**RE: SUBMISSION TO SSD-82899468 FOR RESIDENTIAL FLAT BUILDING WITH INFILL AFFORDABLE HOUSING**

I refer to the State Significant Development Application SSD-82899468 for the purpose of a Concept Development Application (**Development**) seeking concept approval for the demolition of existing buildings and associated structures, tree removal and site clearing and construction of a multi-storey residential flat building with in-fill affordable housing above basement car parking and associated landscaping at No. 1-5 Nelson Road, Lindfield (**Site**).

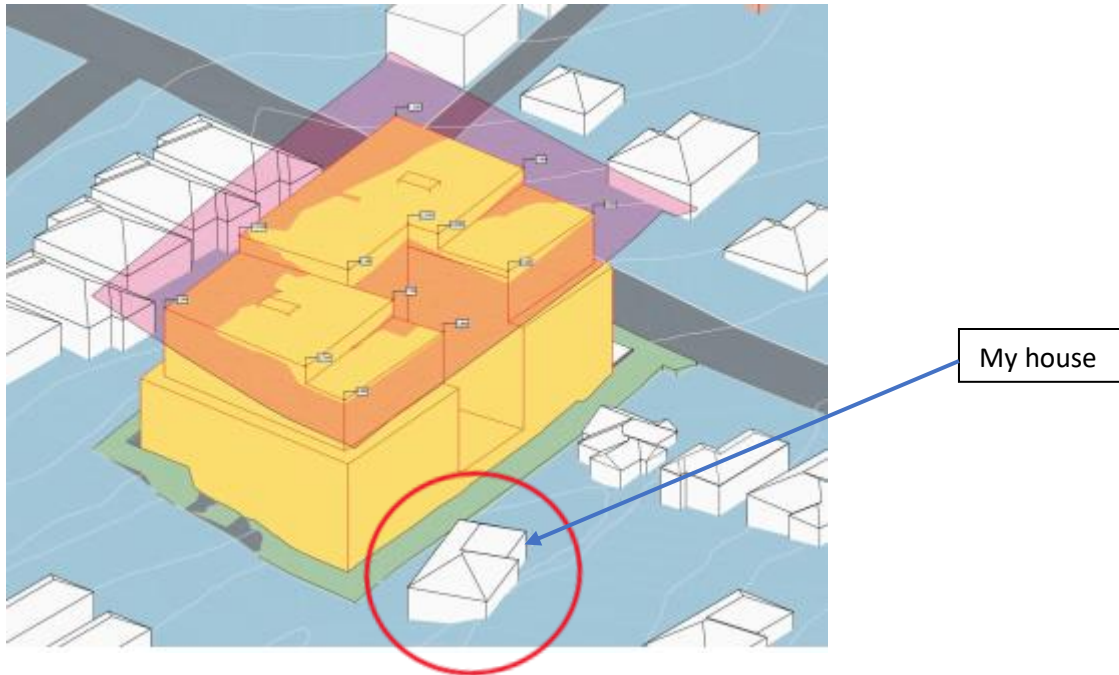
Only a small section of 1 Nelson Road, Lindfield was assessed as being within 400m of Lindfield Station, however the entire 1,636m block was included in the TOD map. This crude method of determining what properties do and do not lie within the TOD results in a strange "pan-handle" shape and it is very clear from

Planning NSW's own TOD map that almost all of 1 Nelson Road lies outside of the 400m radius from Lindfield Station, and that 3 and 5 Nelson Road (which make up two-thirds of the Site) lie fully outside the TOD:

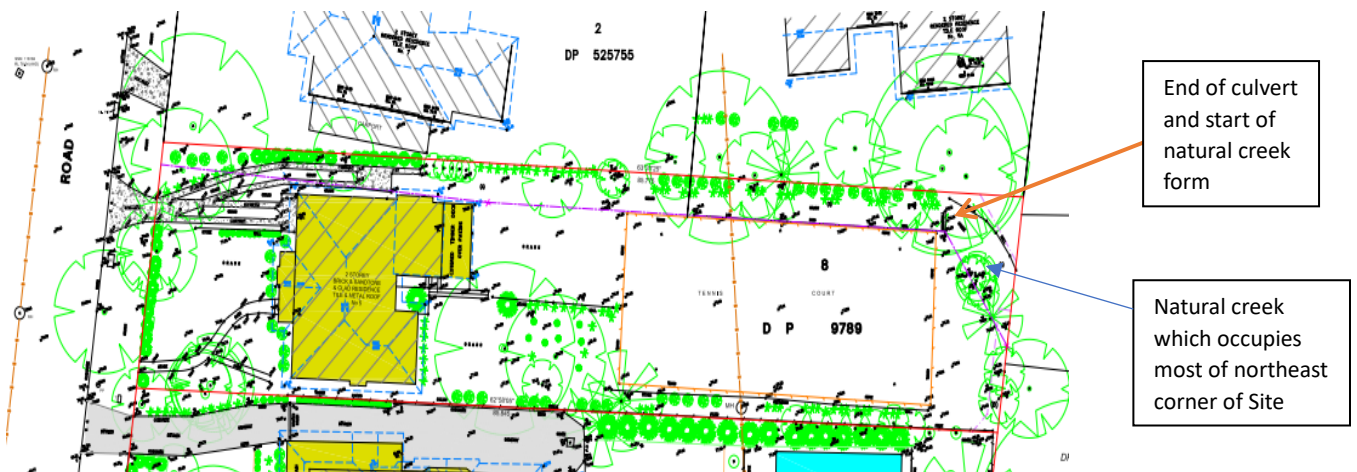
I dispute that the extra height is because of the topography at all, despite being used as justification for it. What is clear is that the topography will exacerbate the impact that the additional height will have on my amenity as an adjoining landowner. My house is located on adjoining land to the northeast of the site precisely where the height of the building is at its highest (11-storeys at the northeast corner). The following snip is Figure 2 Proposed Height Banket Diagram at page 5 of Appendix 31 – Clause 4.6 for Building Height. That is my house shown circled in red:

I totally reject this assertion as it is patently untrue. If the proposed Development proceeds there will be an 11-storey building literally 6m away from our shared dividing fence. It will tower over my 2-storey house and be visible from everywhere outside my house as well as from most rooms inside.

If built, the development will tower over my property and will be visible from the garden (which it will loom over), as well as all 4 bedrooms and downstairs living area that face the Site. It will also completely block our view of sky when looking in the direction of the Site.

Clearly shows the creek running through the Site

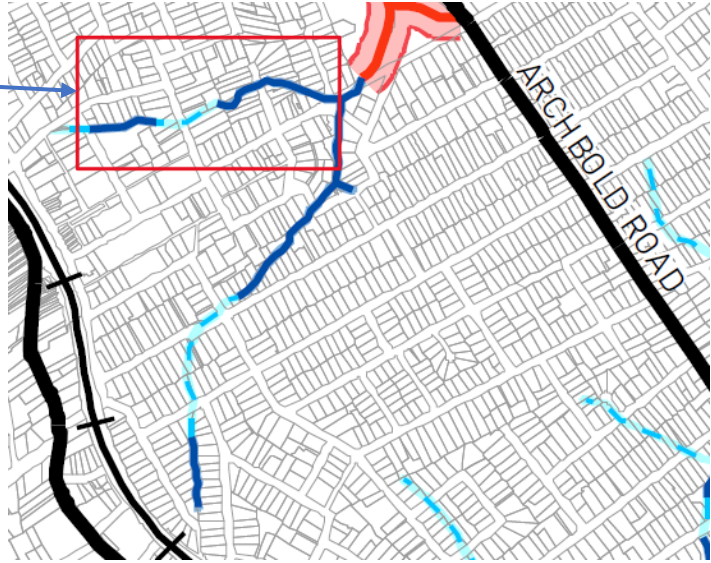
Unsurprisingly, the creek is included on Ku-Ring-Gai Council's Map of Riparian Lands and is defined as "Category 3 and 3a Riparian Land under Clause 6.4 in KLEP 2015:

The area in the red box on the above snip taken from the Council's Map of Riparian Lands shows the creek which continues to run above ground once it leaves the Site, past houses downstream from the Site where it joins in with Gordon Creek before eventually discharging into Middle Harbour.

The part of the creek beyond the culvert on the Site is defined as Category 3 Riparian Land (shown as dark blue on the map above).

Category 3 Riparian Land requires a protected zone of 10m from the banks of the waterway, so 10m from the banks of the creek in this case would require a much wider setback from the northern and eastern boundaries than the proposed 6m setback on the current concept plan.

Category 3a Riparian Land requires a protected zone of 10m from the centre of the waterway, which would require a much greater setback from the northern boundary, not 6m as is currently being proposed.

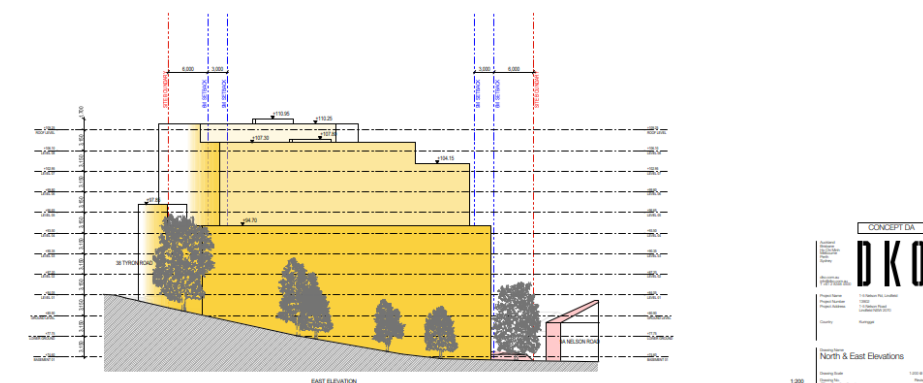
- an interface of an 11-storey apartment building directly next to my two-storey single dwelling home in a heritage conservation area is not appropriate, and
- the requirements of the SEARS in this regard have not been met by the concept plan.

Given the sloping nature of the land, what is 9-storeys when viewed from Nelson Road is in fact 11-storeys when viewed from the north and east. I refer you to the Elevations in the Proposed Concept Masterplan (Appendix 9) showing my house (a two-storey residential dwelling) being towered over by an 11-storey building located on the other side of our shared boundary:

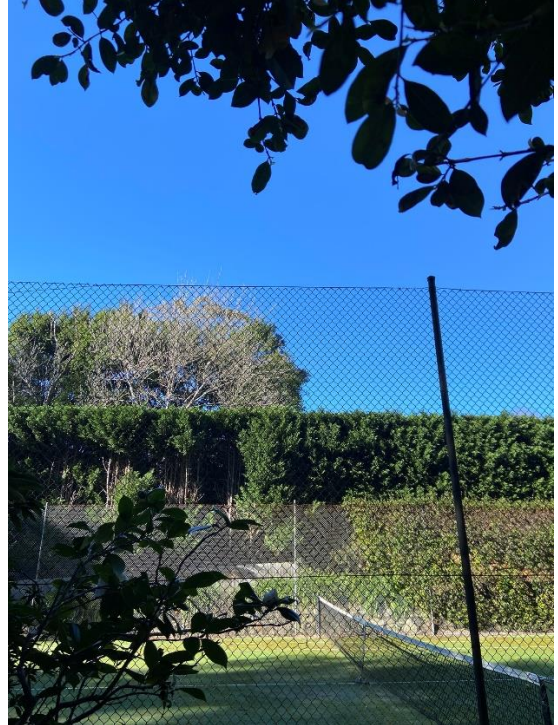
In addition, as my property is downhill from the Site, the impact is even worse since we will have to look up at the proposed Development from our property, as evidenced by these photos taken from my garden looking up and in the direction of the Site:

Where we currently see greenery and sky, we will only see an 11-storey apartment building from this aspect if the proposed Development goes ahead.
